Supplementary Report

Rum Jungle Rehabilitation Project – Environmental Impact Statement

| Date Issued | 18/06/2020 |

Figure 3-6 Borrow Area A riparian vegetation buffer

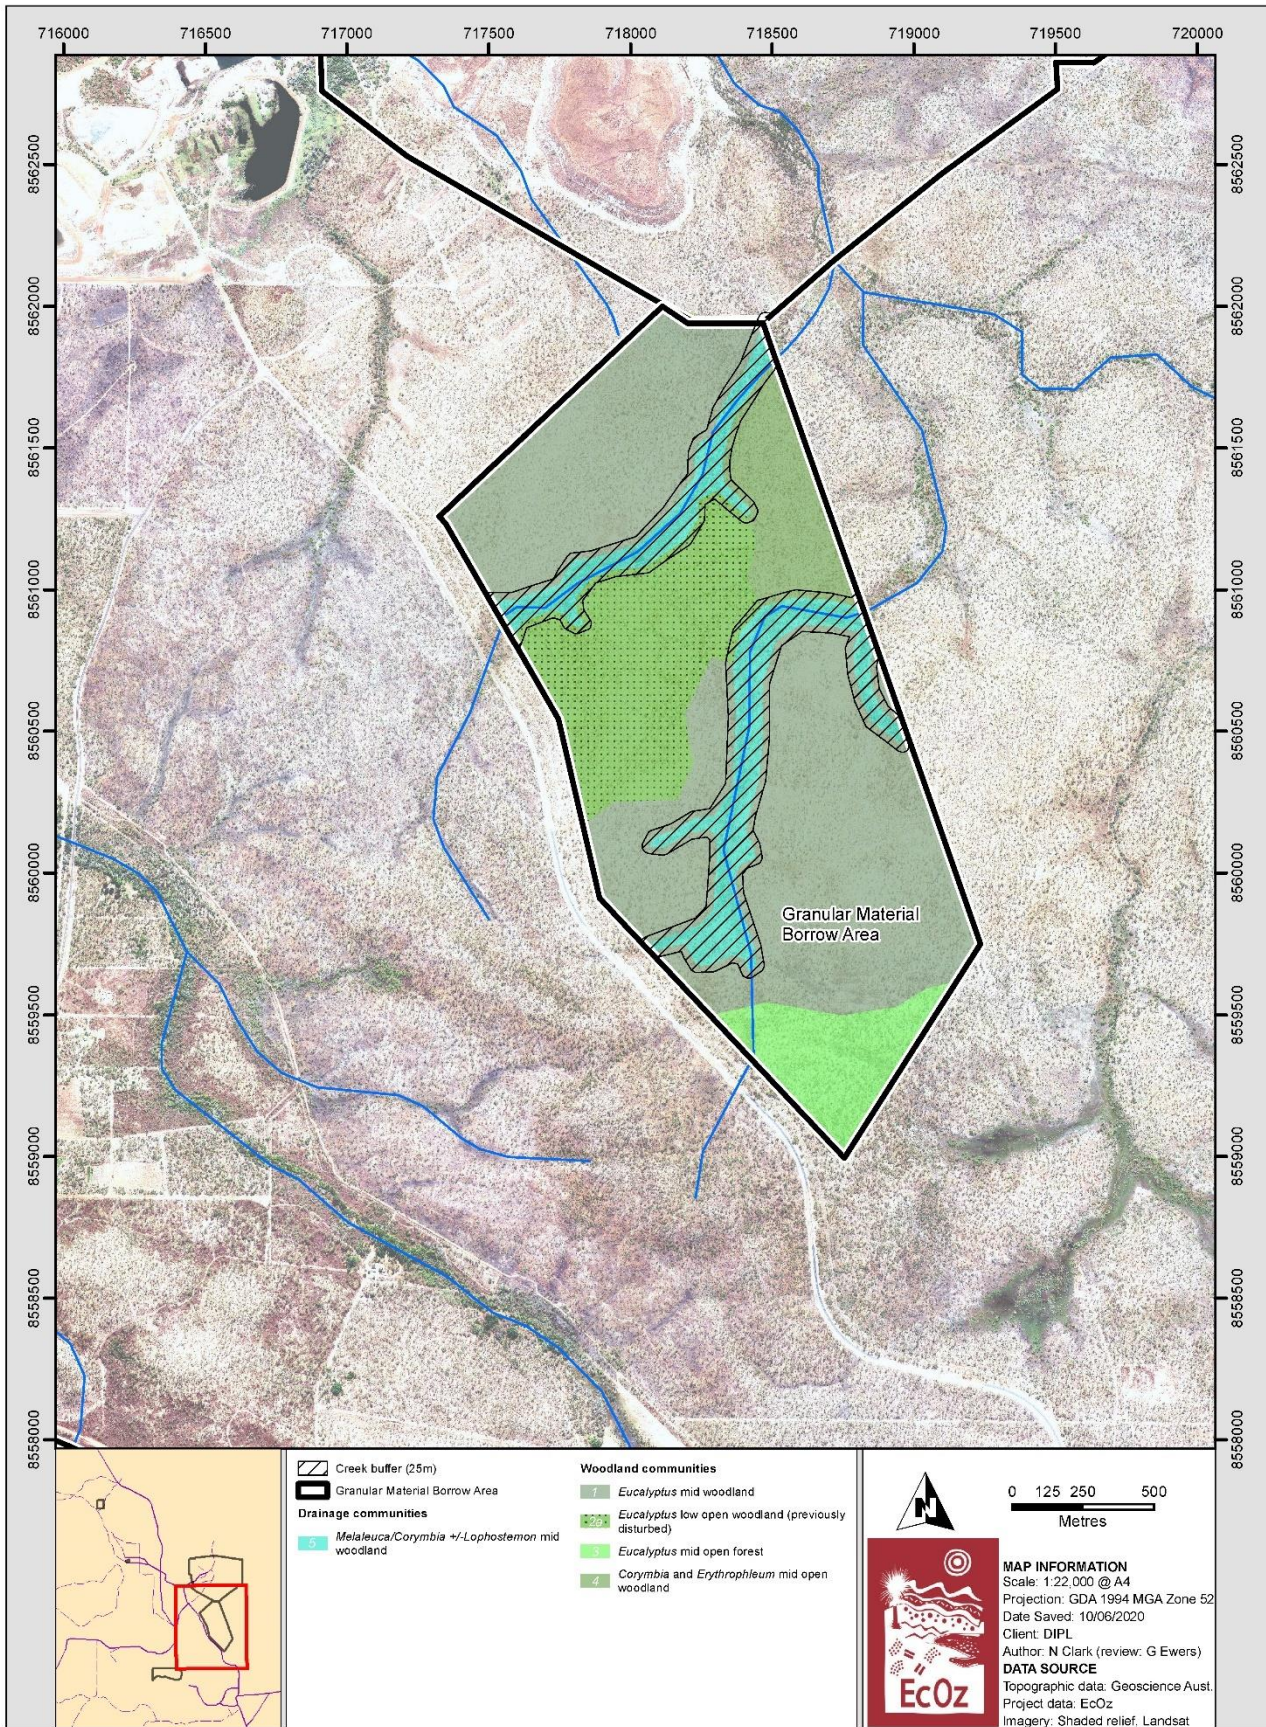
| | | | | <p>a protective buffer of native vegetation between the clearing area and the riparian vegetation.</p> <p>Provide further information about the proposed clearing locations and environmental values in the Proposal area (Rum Jungle Mine Site, satellite sites, borrow areas), including:</p> <ul style="list-style-type: none"> maps of proposed clearing/disturbance areas in relation to vegetation types. Maps should identify sensitive and significant vegetation types, wetlands and GDEs, and their respective native vegetation buffers in line with Land Clearing Guidelines (DENR 2019) a table quantifying (ha) areas to be cleared of each vegetation type in the Proposal area. The table should identify sensitive and significant vegetation types, GDEs and wetlands. | <p>weed-free riparian vegetation will be cleared for the haul road within the granular material borrow area.</p> <p>A quantification of the areas (in hectares) of each vegetation type that will be disturbed in the Proposal area is presented in Table below and Figure 3-6, Figure 3-7, and Figure 3-9. Within the Rum Jungle mine site, 78.8% of the disturbance footprint has been previously disturbed by mining activities. This land has either regenerated with native species (but is heavily compromised by Gamba Grass infestations), remained cleared or is covered solely in Gamba Grass. A further 17.4% was remnant bushland that has now been heavily-invaded by Gamba Grass. Only 4.0% of the Rum Jungle mine site disturbance footprint is intact native bushland. That bushland occurs primarily on the site of the eastern WSF, with the remainder within the haul road corridors.</p> <p>The entire low permeability material borrow area is heavily-infested by Gamba Grass and was previously disturbed. Of the granular material borrow area, 19.9% has been previously disturbed – see Table below and Figure 3-7. The remaining woodland is intact, with only patchy weed infestations. Extraction of materials from that site will concentrate on previously-disturbed areas, with only 2 ha of remnant bushland having to be cleared.</p> <p>Apart from the riparian vegetation mentioned above, the only other significant vegetation type that will be disturbed is a number of small patches of vine thicket (totalling 0.46 ha). That vine thicket is on the very eastern margins of the patch. No wetlands will be cleared.</p> <p>Quantification of vegetation types to be cleared</p>

Figure 3-8 Haul Roads (yellow indicating external haul roads and red indicating internal haul roads).

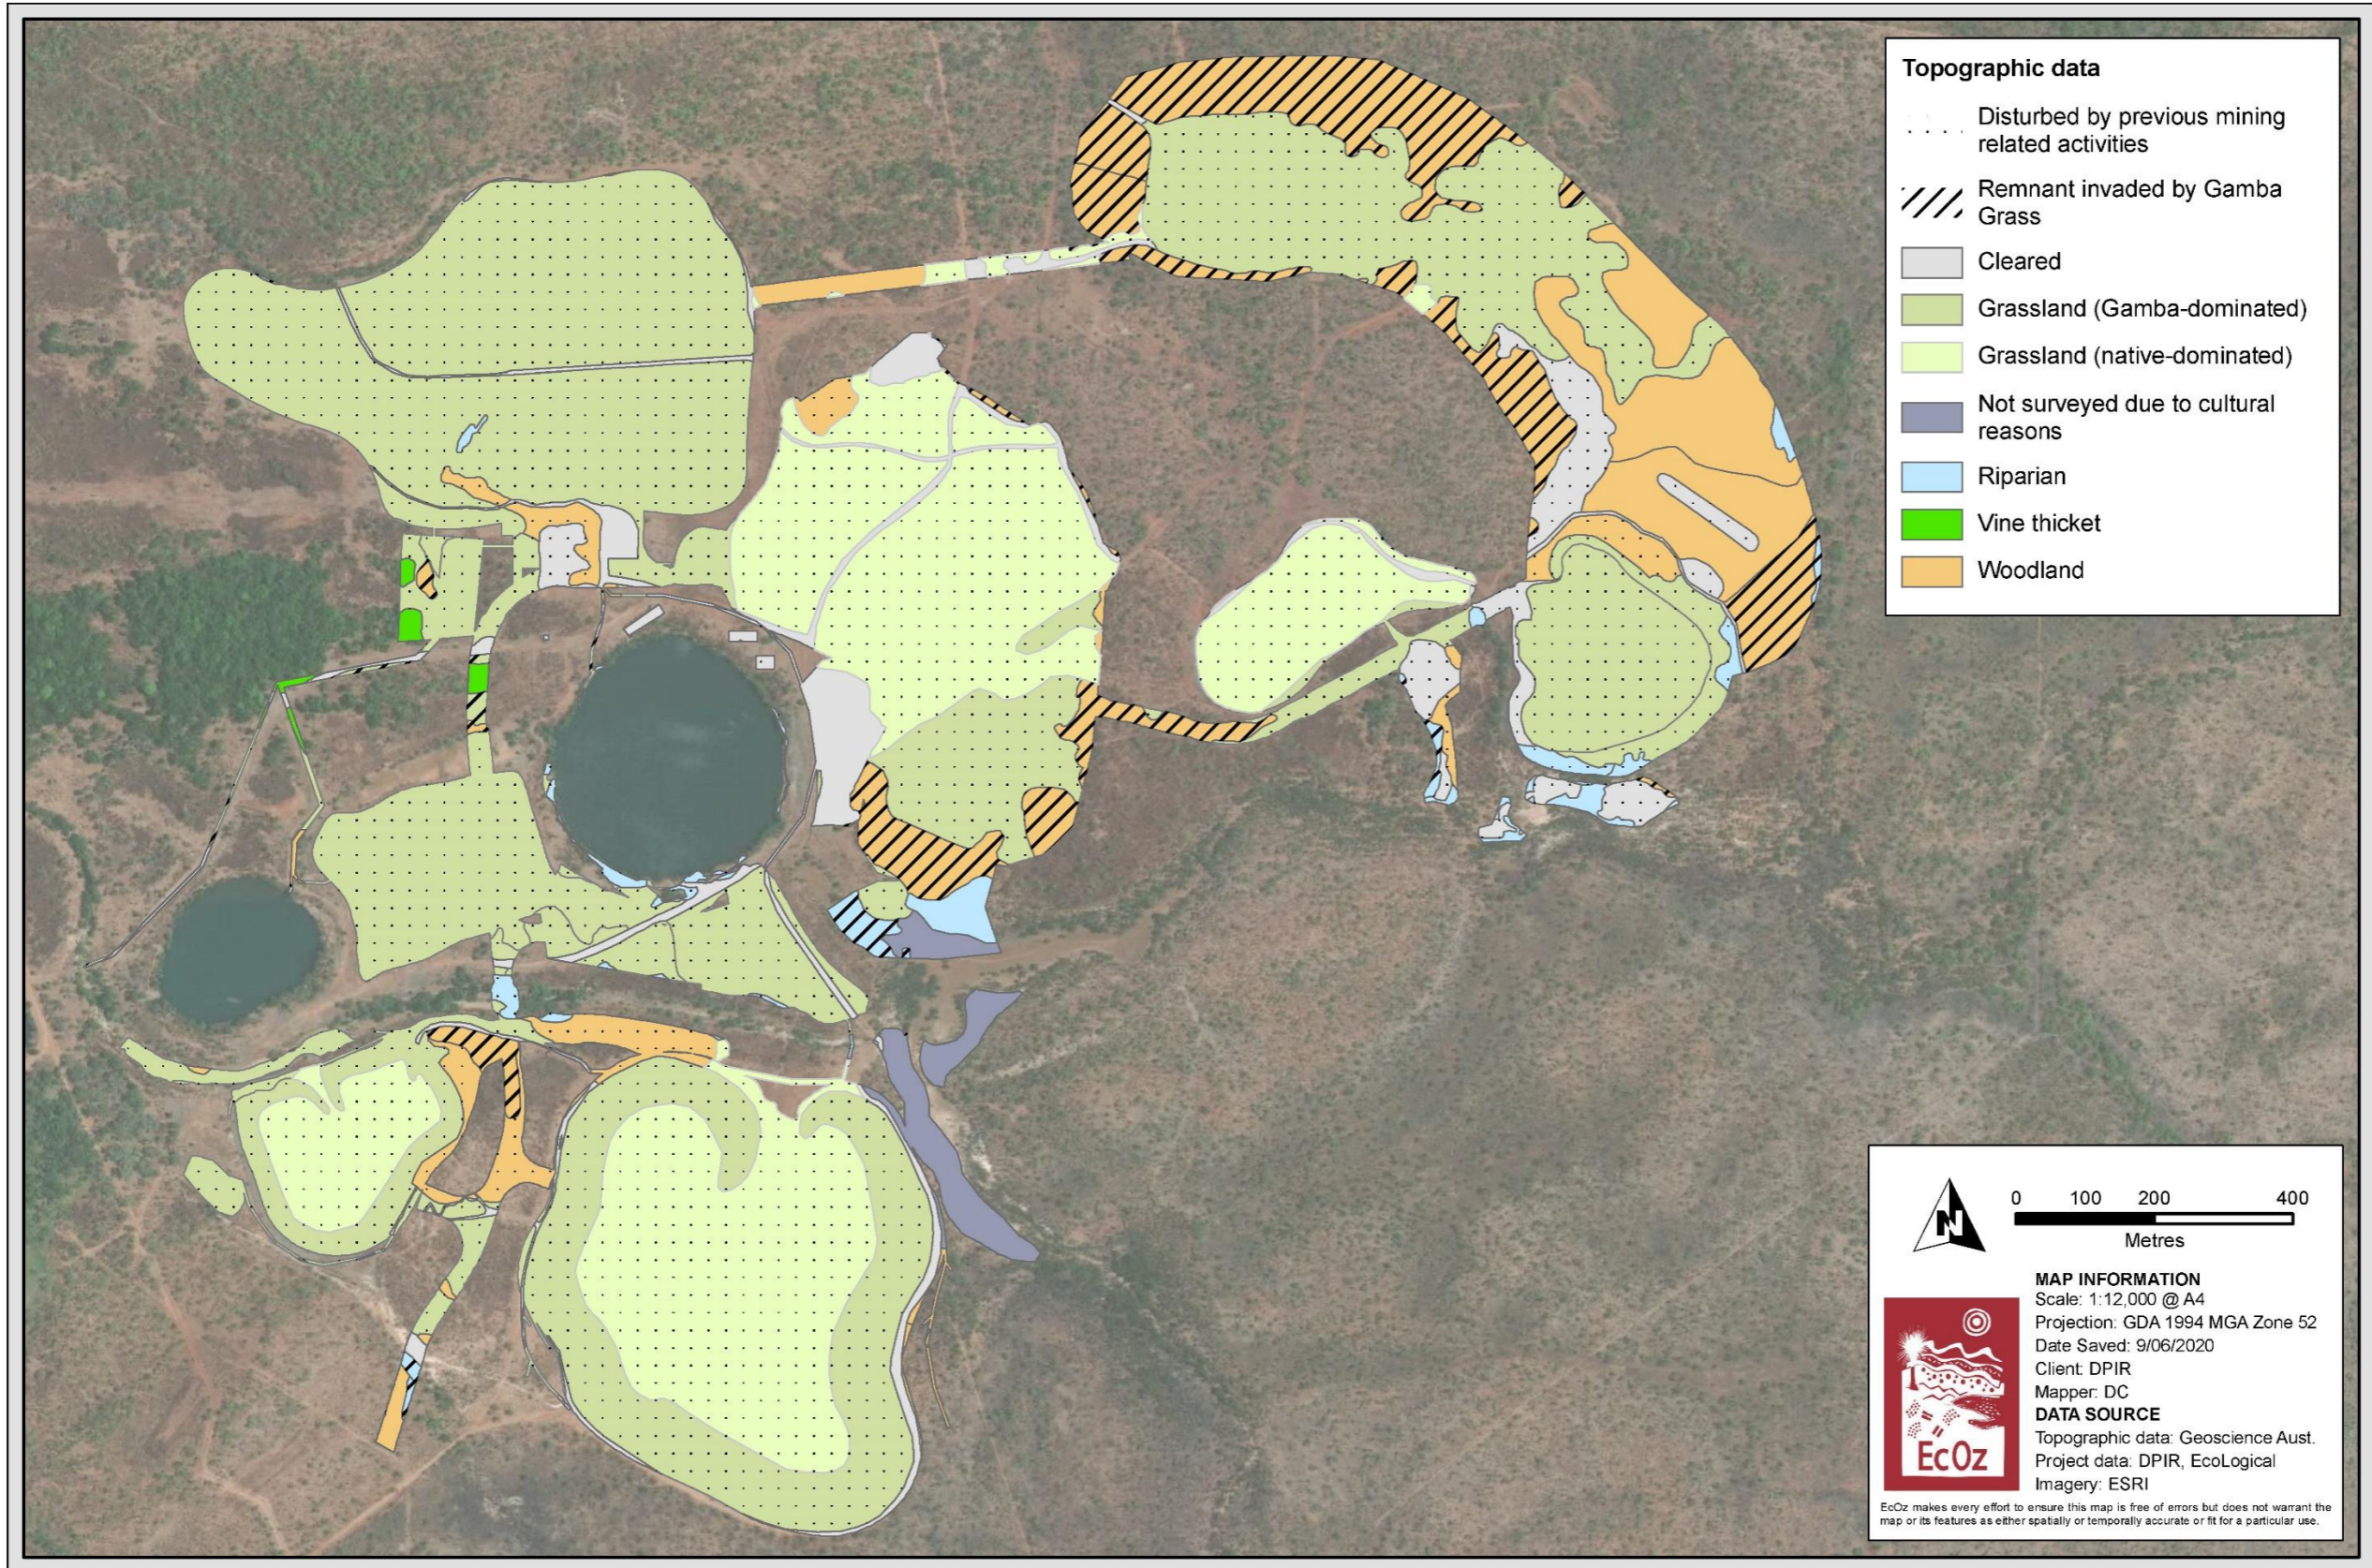
| | | | <p>2.5.4 Transport and Logistics Network Figure 2-4 Indicative haul road layout</p> <p>5.3 Existing Services and Infrastructure Table 5-1</p> <p>13.2.3 Services and Infrastructure</p> | <p>the use of a borrow material source that would require haulage on public roads. The Draft EIS includes a commitment to develop a Traffic Impact Assessment (2.5.4) and comply with traffic management requirements (13.2.3) in line with Department of Infrastructure Planning and Logistics (DIPL) requirements if public roads are likely to be affected by the Proposal.</p> <p>There is some concern that road works in the event of Proposal-related road upgrades and increased heavy vehicle traffic could impact on tourism and particularly visitors to Litchfield National Park.</p> <p>Provide:</p> <ul style="list-style-type: none"> information about potential socio-economic impacts of traffic on public road networks and users, including tourists and tourism operators, and associated avoidance, management and mitigation measures. commitment to consult with Parks and Wildlife Division about any vehicle traffic proposals that may impact visitors to Litchfield National Park. | <p>Importantly, at a time closer to project implementation, further consultation with DIPL may provide an improved understanding of peak traffic movements at that time. There is scope within the current project design and schedule for any traffic activities deemed higher risk to be shifted to non-peak hours as an option for the operational management of stage 3 traffic impacts.</p> <p>A commitment to consult with Parks and Wildlife Division about any vehicle traffic proposals that may impact visitors to Litchfield National Park is provided in Section 4.</p> |

The impact and mitigation measures of external haul roads are outlined in the SLR (2020g) Traffic Impact Assessment included in Appendix 16. The use of the existing infrastructure will not require additional land clearing. As indicated in Figure 3-8, the majority of internal hauls roads for the project occur on already cleared land or within the borrow areas except for 0.23 ha of clearing area. The land clearing requirements of internal hauls roads have been included in response 33 in Section 2. The final location for the haul road between Borrow Area B and the main site in Figure 3-8 is indicative; the final route will aim to select the route of least disturbance.

Figure 3-14 Validated Geological Map

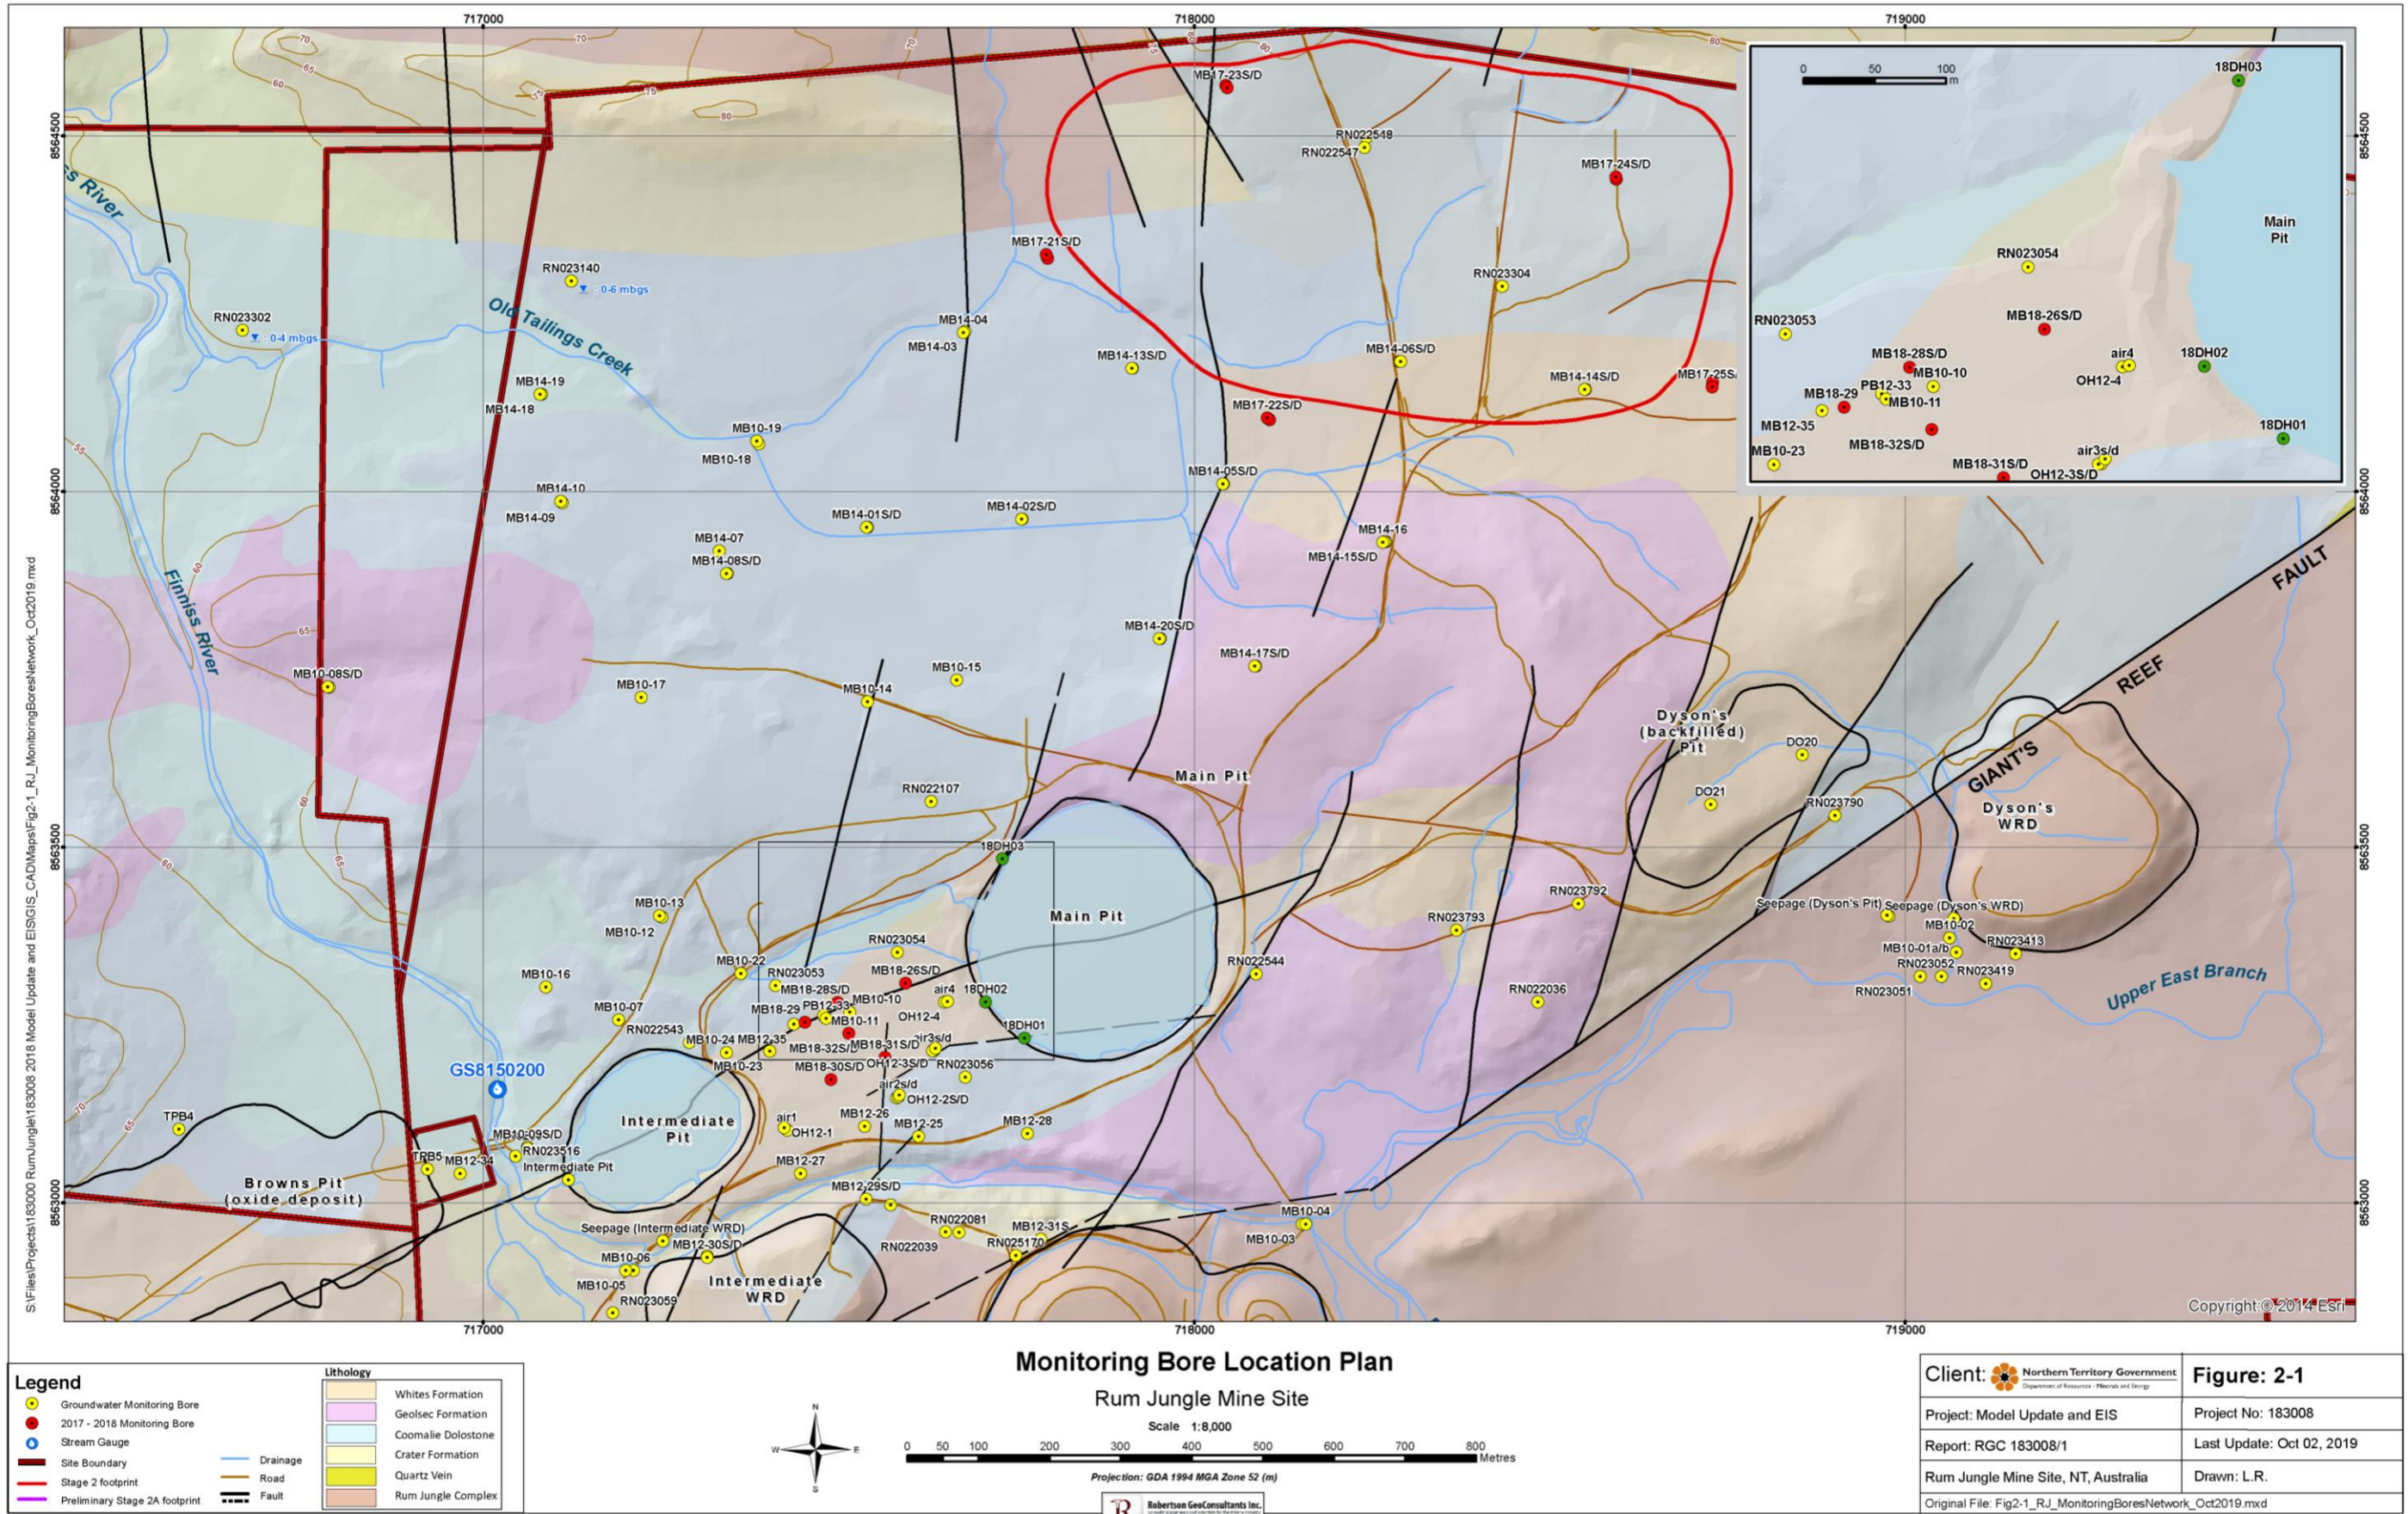
| 18 | NT EPA | Local geology/lithology | 9.1.2 Geology | <p><i>Figure 9-2: Geology of the Rum Jungle Mineral Field showing uranium and other mineral occurrences (Ahmad and Hollis, 2013) shows the geology of the region. A local lithology map was provided in Appendix Robertson GeoConsultants 2019. It is unclear if the lithologic units presented in the report were derived from/verified with local bore drill data.</i></p> <p>Provide a field verified map of the local geology/lithology in relation to the location of the Proposal area, including borrow areas (see similar map in Appendix Robertson GeoConsultants 2019).</p> | See maps presented in Section 3.8. |

The main Rum Jungle site verified geological map provided by Robertson GeoConsultants is provided here in full as requested. Additionally, another map of the borrow locations over the geological base map is provided; however, it is important to note that this map has not been field verified.
